ADDENDUM NO. 1 TO THE CONTRACT DOCUMENTS

SYRACUSE HANCOCK INTERNATIONAL AIRPORT REHABILITATION OF DEICING STORAGE FACILITIES

FAA AIP PROJECTS NO. 3-36-0114-XXX-18

SYRACUSE REGIONAL AIRPORT AUTHORITY IFB REFERENCE #2018-02

FIGURE 1

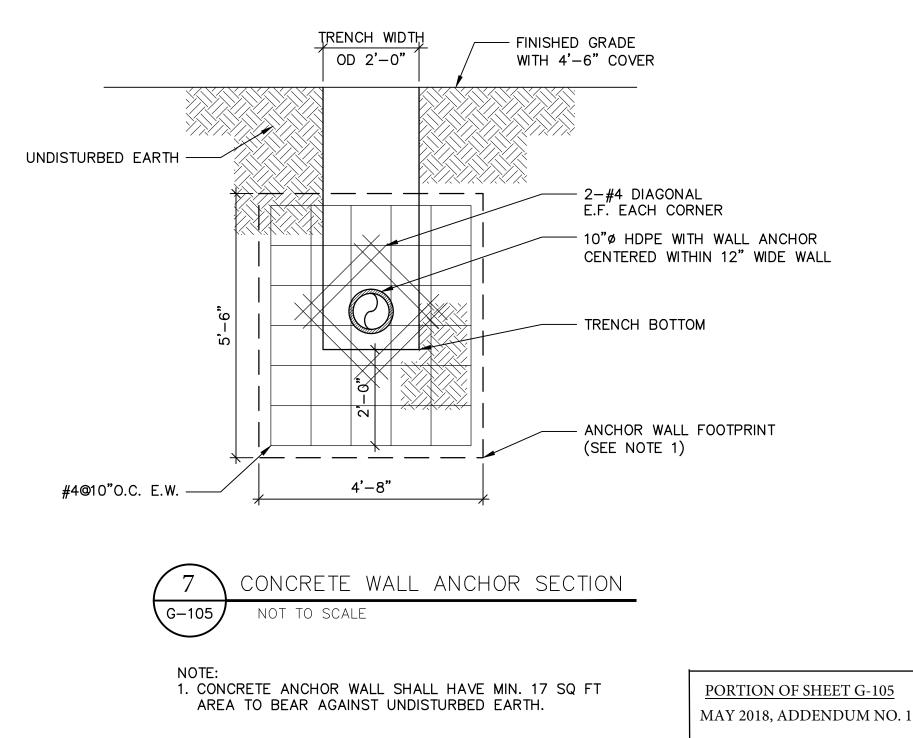
- 1. "2" Ø PIPES IN TRENCH SHALL BE HEAT-TRACED AND INSULATED"
- 8. Contract Drawing G-105:
 - a. Insert: Attached Figure 1 "CONCRETE WALL ANCHOR SECTION"
- 9. Contract Drawing G-106:
 - a. <u>Delete</u>: from Bollard
 - "8" DIA. 3/8" THICK STEEL POST FILLED WITH CONCRETE PAINTED YELLOW."

STORAGE TANK CHEMICA PLANS AND DIA

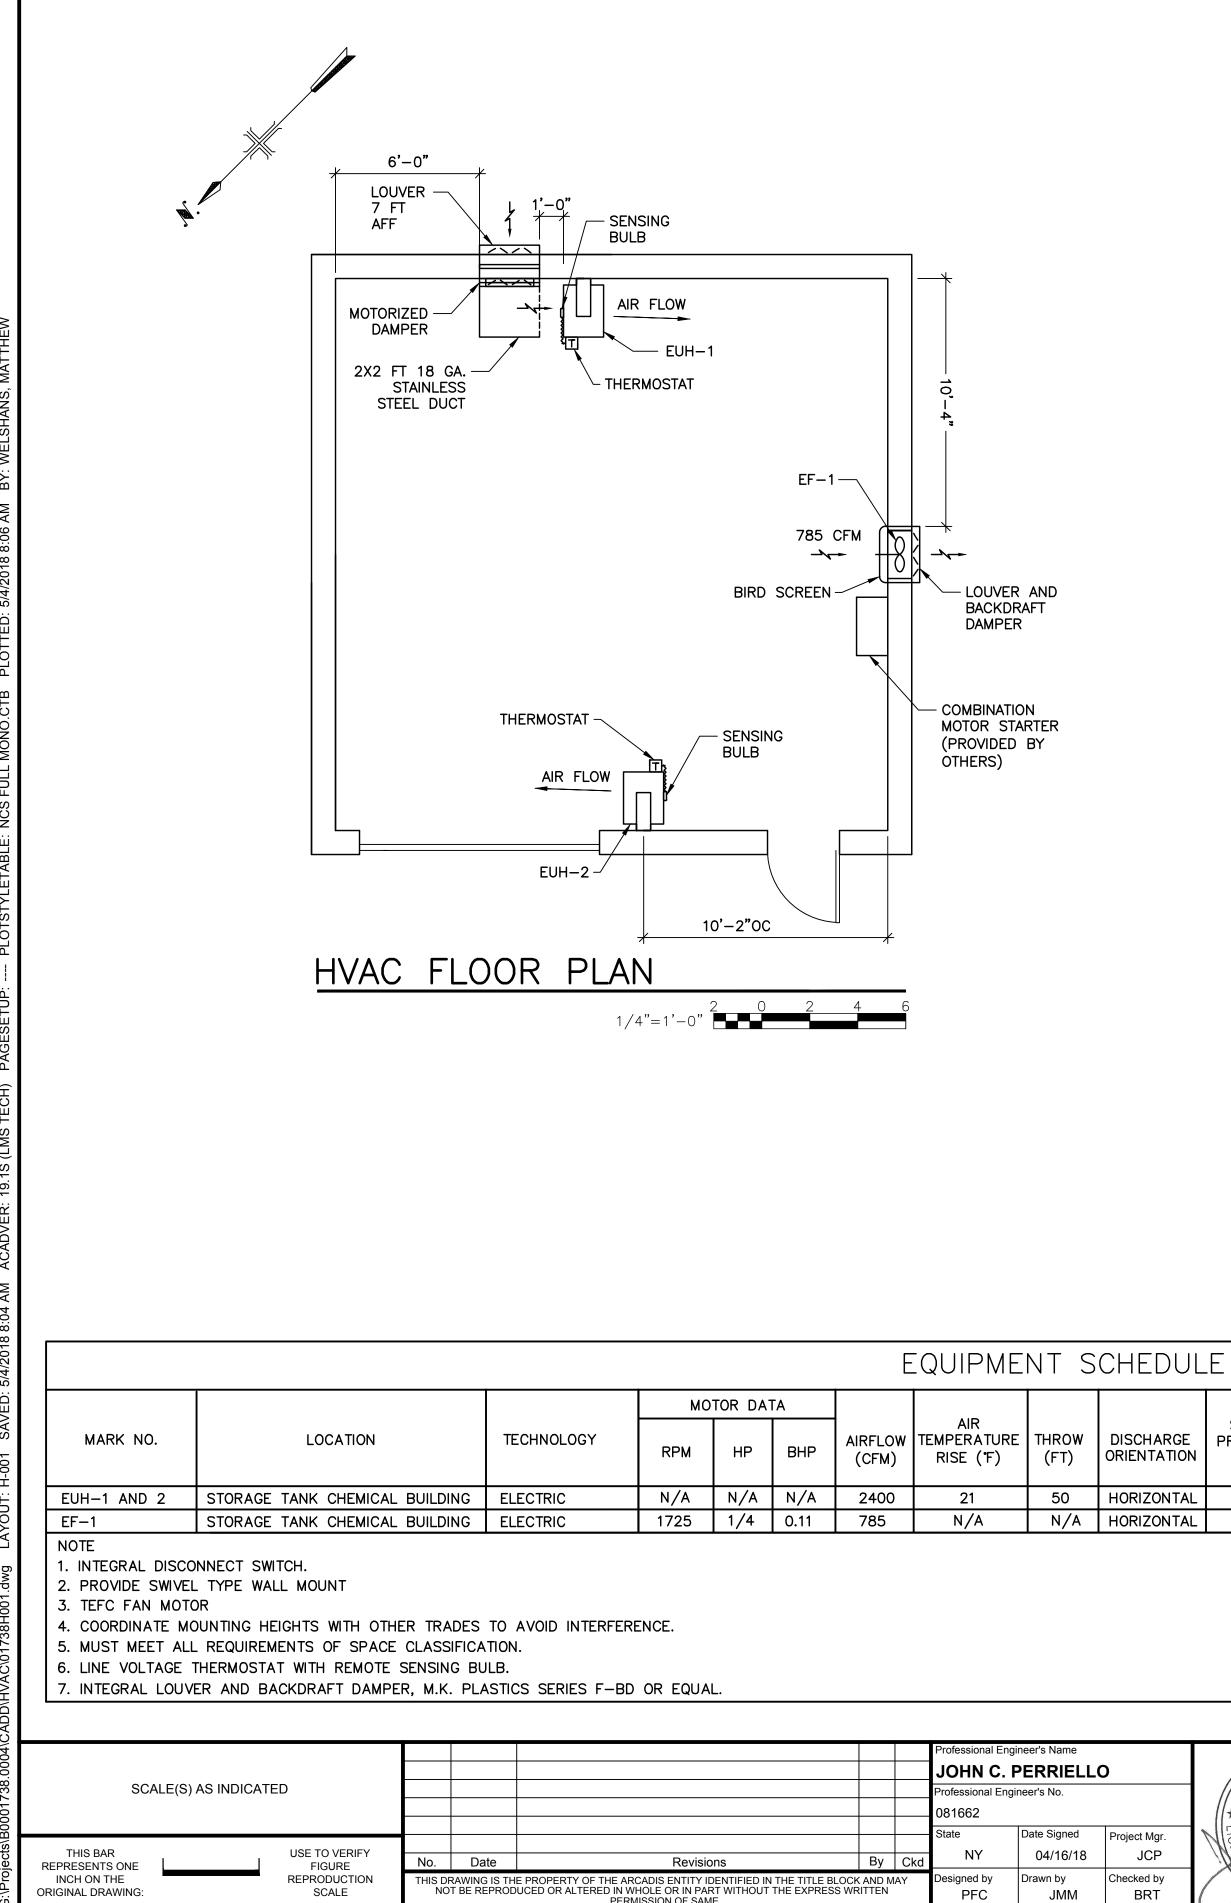
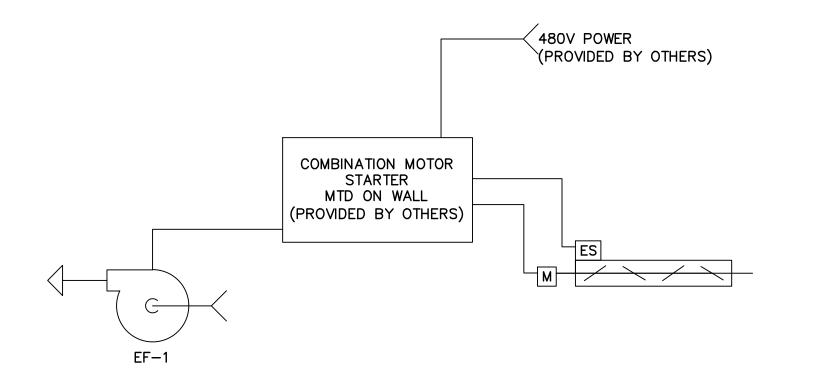
- Contract Drawing H-001, attached to this Addendum: <u>Insert</u> Contract Drawing "H-001 STORAGE TANK CHEMICAL BUILDING HVAC PLANS AND DIAGRAMS" in its entirety after all electrical "E" drawings.
- E. IN THE REFERENCE INFORMATION:
 - 1. See ATTACHMENT NO. 2 for Subsurface Exploration Site Characterization Report.
 - a. <u>Delete</u> within Appendix B Reference Information, second part titled "Subsurface Exploration Report" in it's entirety.
